Technical Review Committee

**CITY OF DELAND
WEDNESDAY JUNE 18, 2025 AT 1:30 P.M.
CITY OF DELAND TRC MEETING ROOM
DELAND, FLORIDA**

City of DeLand
SP24-134
New York Ave
Apartments

Issues for record SP24-134
Job Address: 225 W NEW YORK AV, DELAND FL 32720
Job Description: 84 multi-family unit apartment development

City of DeLand
SP24-134
New York Ave
Apartments

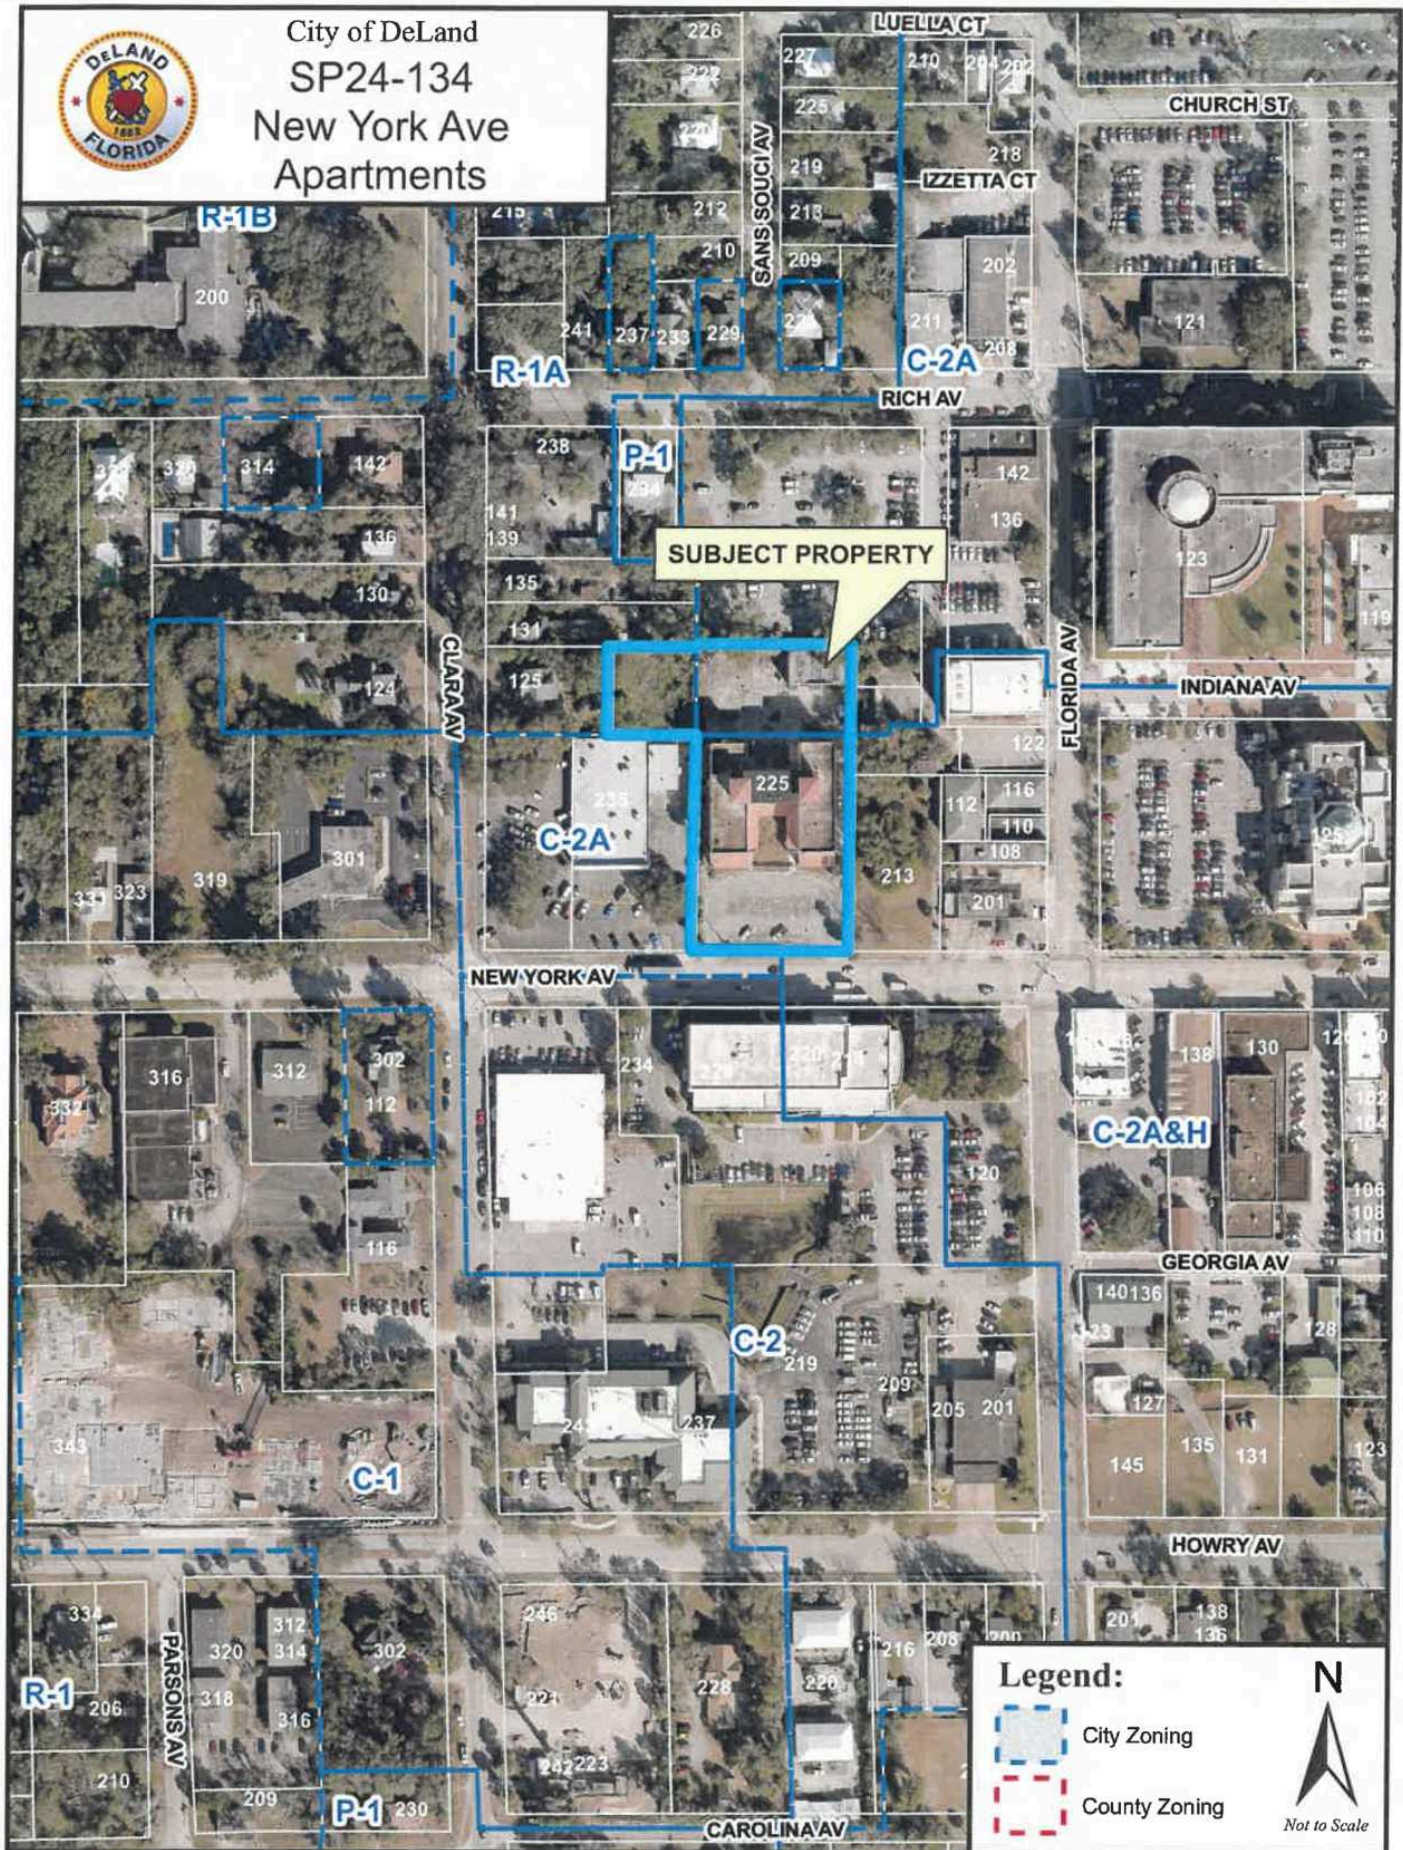
Discipline	Status	Details	Attached To	Created By	Last Updated By	Modifications Required
Runoff Collection						
Engineering	Draft	1. Please provide check dams along the swale that runs southward along the eastern property line to minimize stormwater discharge onto the public sidewalk. 2. Drainage Note 1 indicates that all downspouts shall be connected to the stormwater system, but it appears problematic on the east and south sides of the building. Please provide details as to how this is to be accomplished.	C300	Steven Danskine	Steven Danskine	Yes
Tree Disposition Summary Table						
Forestry	Draft	The table will need to be updated to reflect what is now shown to be preserved/removed on the plan.	TR1.1	Kit Dennis	Kit Dennis	Yes
Trees 40 & 43						
Forestry	Draft	Is removal of trees 40 and 43 still necessary now that you are not proposing the connecting drive to the Volusia County parking lot? If they can now be preserved, please do not show them, or calculate them, as removals on the plan.	TR1.1	Kit Dennis	Kit Dennis	Yes

Planning	Draft	Mass and Scale HPB has approved a COA. City Commission will review the architecture and mass, scale, and context will be evaluated. Please provide information related to the proposed mass and scale in light of the increased height (77 feet). 1. The building mass and scale needs to be broken up – “buildings in established areas shall be designed for a compatible relationship to the existing surrounding neighborhood. Structures shall utilize similar architectural style, character, massing, materials, color, or other elements so as to relate to the surrounding neighborhood.” (Section 33-94.03(b)3). This site is located near 1, 2 and 3 story buildings. 2. The building should provide transitions between the adjacent buildings and the building mass shall be varied by height and width so it appears to be divided into distinct massing elements and architectural details can be viewed from a pedestrian viewpoint.” (Section 33-94.03(b)4.b). The massing of a 5-story building is out of character with the area. The historic Putnam Hotel stepped back the height of the building to maintain a pedestrian scale at the street. Please revise. 3. Variations in the roofline shall be used to add interest to and reduce the massing of the buildings. Please revise. 4. Building design shall have characteristics and elements that relate favorably to the pedestrian scale of the district (33-94.04(a)5). The 5-story building adjacent to the street does not relate to the pedestrian scale of the district. Please revise. 5. The architectural design of structures shall bear a complementary relationship to the existing architectural context of the surrounding area (similar or related architectural styling or character; similar or related massing, proportions and scale, along with the repetition of the relationship of solids and voids in the architectural design; similar or		Carol Kuhn	Carol Kuhn	Yes

Planning	Draft	6-foot sidewalk along New York Avenue. If possible, please increase the sidewalk width from 5 feet to 6 feet along New York Avenue.	C100	Carol Kuhn	Carol Kuhn	Yes
Planning	Draft	Trash roll-out area The trash roll-out area should be in an enclosed corral area. The enclosure should be designed with the same materials as the principal structure. Please include a dimensioned detail.	C100	Carol Kuhn	Carol Kuhn	Yes
Planning	Draft	Recorded cross access easement The recordation information must be provided on the final plan set for the off-site access drive shown on the adjacent property. The book and page must be included on the final site plan, prior to the issuance of a development order. This is the only access to the site and, without this recorded cross access easement, there will be no access to the site.	C100	Carol Kuhn	Carol Kuhn	Yes
Planning	Draft	Parking The applicant has proposed 20 off-site parking spaces to meet the City Commission's conditional approval for the parking reduction request. However, the applicant has proposed this off-site parking for 5 years, not the full length of time associated with the affordable housing, as indicated by City Commission. Also, the proposed off-site parking may be revoked by the County at any time. An alternative plan must be provided if the County revokes the parking. The City Attorney and City Staff are reviewing the proposal for the off-site parking. Additional comments and revisions will be forthcoming.	C100	Carol Kuhn	Carol Kuhn	Yes

Planning	Draft	Emergency Access Will there be an emergency access point, since the secondary access point has been removed? Please clarify.	C100	Carol Kuhn	Carol Kuhn	Yes
Planning	Draft	Note 20 - irrigation Note 20 - states irrigation is to be provided by city potable water - but irrigation plan indicates a well will be used for irrigation. Please revise for consistency.	C100	Carol Kuhn	Carol Kuhn	Yes

Planning	Draft	Bicycle Parking Count A total of 8 exterior bicycle parking spaces are shown on the plan, and 4 are shown in the calculation. Please revise the plan to reflect the correct total in both locations.	C100	Samuel Nelson	Samuel Nelson	Yes
Planning	Draft	Landscape Island Dimensions No dimensions are provided for the vehicle-use area landscape islands. These landscape islands are required to have a minimum width of nine feet, and a minimum size of 72 square feet (33-92.02. (a)). Please show the dimensions of the islands on the plan.	LA1.1	Samuel Nelson	Samuel Nelson	Yes
Planning	Not Accepted	Continuous run of parking Landscape areas shall be provided to break up excessively long continuous runs of parking space. Generally, a parking bay shall not contain more than 15 continuous parking spaces or extend more than 150 feet, whichever is more restrictive, without being broken up by a landscaped area. (33-92.02). Please revise to meet the landscape requirements or request deviation from the standard from City Commission. Last comment from reviewer: Section 33-92.02 requires landscape areas to break up continuous parking bays of 15 parking spaces or 150', whichever is more restrictive. The northern island with the proposed sidewalk will not meet the Land Development Regulations. Please revise plan to show the required landscaping along with the proposed sidewalk. Last response: Please see enclosed plans, the parking runs do not exceed 15 spaces without a break. There is one island along the north property line in between parking runs that contains a sidewalk only. Due to the limited amount of space, and need to provide the sidewalk connection, it was not possible to plant trees in this island. All other portions of the plan comply with the planting requirements.	C100	Kendall Story	Deborah Glick	Yes

Parking for leasing office Where is the leasing office parking area? Please designate and provide parking information for the leasing office on the site plan.				
Planning	Not Accepted	Last comment from reviewer: Parking waiver approved by Commission on April 21, 2025 requires an additional 20 spaces be provided. Please update the plan to include the additional parking and designate leasing office parking area. Last response: This item will be included in the revised parking analysis and parking variance request to City Council.	E1.2	Carol Kuhn	Deborah Glick	Yes
		Foot Candles A maximum of 0.5 foot candles are permitted at the property line. This is being exceeded in the NE corner of the site. Please revise. (see markups)				
Planning	Not Accepted	Last comment from reviewer: Maximum foot-candles at the property line now exceed 0.5 at the NW corner. Please revise so that foot-candles do not exceed 0.5 at the property line. Additionally, the foot-candles have been removed from the southern driveway apron property line. Please provide foot-candles at this location. Last response: The Photometrics have been updated per overall plan changes.	E1.2	Kendall Story	Samuel Nelson	Yes

Access Easement Documentation Shared access to the west and north is shown on the site plan. Other than these proposed shared access points, the site has no other access. The shared access easements must be recorded prior to taking this Class IV site plan to Planning Board, as these access points are vital to project. The book and page of each recorded easement must be included on the site plan. Last comment from reviewer: Repeat comment. Please provide a copy of the draft access easement with Volusia County for the proposed shared access easements on the north and west side of the property. These easements must be reviewed prior to the Planning Board hearing. Last response: Comment acknowledged, this item will be included in the revised parking analysis and parking reduction request to City Council for consideration.	C100	Kendall Story	Deborah Glick	Yes
		Parking stall dimensions Please provide the dimensions of all parking spaces, as some spaces do not meet the City's minimum parking space size of 9 x 19. Last comment from reviewer: Dimensions for the southern run of 5 parking spaces have been removed. Please provide the dimensions of these spaces to confirm	C100	Kendall Story	Samuel Nelson	Yes

City of DeLand
Z24-214
REZONING FOR
ORANGE CAMP COMM. PD

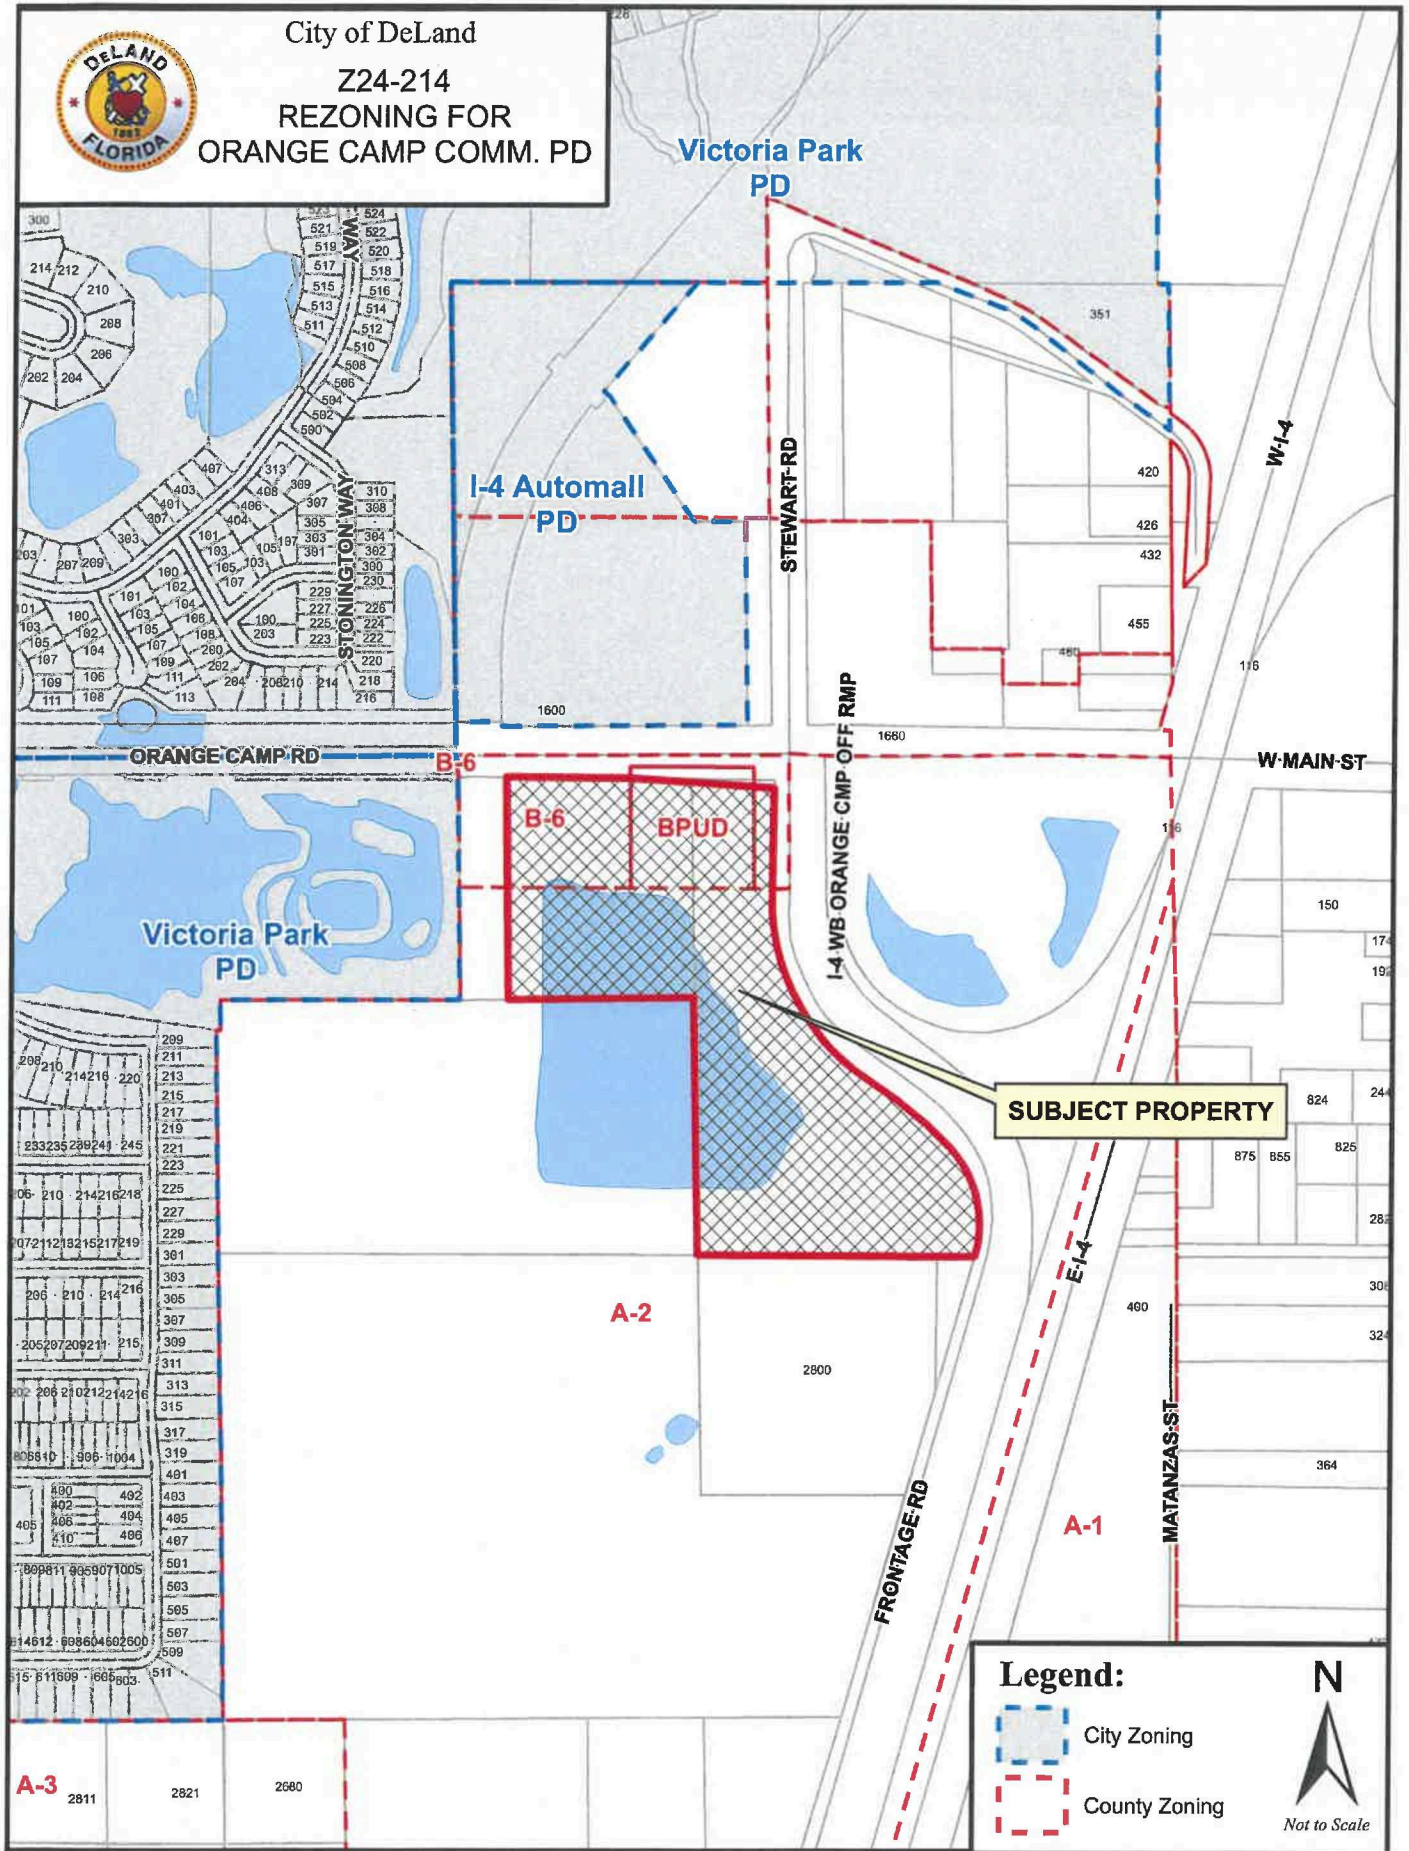
Discipline	Status	Details	Attached To	Created By	Last Updated By	Modifications Required
Engineering	Draft	Stormwater As the borrow pit is encompassed by multiple properties, it cannot be utilized for primary stormwater treatment. The 100yr/24hr storm event must be contained on site before subsequent discharge leaves the property, i.e. the borrow pit.	BP 1	Steven Danskine	Steven Danskine	Yes
Engineering	Not Accepted	Stormwater Item H. Stormwater Drainage should include the requirement to retain the 100yr/24hr storm event onsite. Last comment from reviewer: 1. As the borrow pit is encompassed by multiple properties, it cannot be utilized for primary stormwater treatment. The 100yr/24hr storm event must be contained on site before subsequent discharge leaves the property, i.e. the borrow pit. Last response: PD has been amended to include 100 year 24 hour desien standard	Orange Camp PD Agreement 120524 _Exhi bit.pdf	Steven Danskine	Steven Danskine	Yes

Plant List In order to meet grade one standards, the following specifications will need to be corrected: *Lacebark Elm - At 5" DBH (6" caliper) the height should be 17' and you need to add 6' spread. *Bismark Palm is not on our list of approved trees and will not be counted. *Ligustrum - Our minimum size tree is 3" caliper (2" DBH) 8' height, and 45-gallon container size. Last response: Plan redined amended to address the 17' height and removing Bismark Palm has been scratched as understory tree						
Forestry	Not Accepted	Tree Protection Area Per code, 15% of each outparcel/lot will be required to be designated as tree protection area. Meeting this requirement will not be possible if lots are developed to 85% impervious as proposed, unless there is a site wide TPA plan. If there will be a site wide TPA plan, that will need to be called out in the PD. Last comment from reviewer: Provide verification of a site-wide TPA in the PD agreement. Last response: applicant is proposing a site wide 15% tree overall common tree preservation area within this PD; the tree preservation would be located in Parcel B	BP 2	Kit Dennis	Belinda Collins	Yes

Planning	Draft	Concept Plan The exhibits are inconsistent and do not match.. With the next submittal, use the updated concept plan as the base and update any and all exhibits & supplementals to match with each other.	MASTER SIGN	Christopher Carson	Christopher Carson	Yes

Planning	Draft	Parcel Sizes Once all elements are called out and shown on the concept plan, the appropriate sizes will be able to be drafted into the PD Agreement. After the sizes are determined, remove the sentence "each parcel may be subdivided into additional smaller parcels consisting of a minimum of 9000 square feet upon submittal of a lot split application to the city of DeLand."	Z24-214_PD_Agreement_Redlined_S2-041025 with KCB changes 041725 clean.pdf	Christopher Carson	Christopher Carson	Yes
Planning	Draft	QC Do a general QC to make sure the copy is clean and free of highlights and other errors.	Z24-214_PD_Agreement_Redlined_S2-041025 with KCB changes 041725 clean.pdf	Christopher Carson	Christopher Carson	Yes
Planning	Draft	Reclaimed Water The City shall require that mining sites, including borrow pits, located within adjacent unincorporated Volusia County undergo reclamation as a condition of voluntary annexation. With your next submittal, the procedures and specifications for achieving such reclamation shall be incorporated in the PD.	EXHIBIT B	Christopher Carson	Christopher Carson	Yes

Planning	Draft		EXHIBIT B	Christopher Carson	Christopher Carson	Yes
Site Layout						
With your next submittal, be sure to place all applicable labels including natural water bodies, high water elevations, conservation areas, burrow pit and conservation area setback, and start your design from there to maximize the natural ecological functions of the existing setback.						
Other suggestions include rotating the C-Store w/ Gas 90 degrees with the C-store to the west and the pumps east of the C-Store. Shifting the building to the build-to-line and putting parking and driveways south/east of the building.						
Planning	Draft	With your next submittal, remove the car wash and incorporate retail and restaurant uses into the multifamily component as mixed-use development. Multifamily buildings will need to be shifted to the northern portion of the property.	EXHIBIT B	Christopher Carson	Christopher Carson	Yes
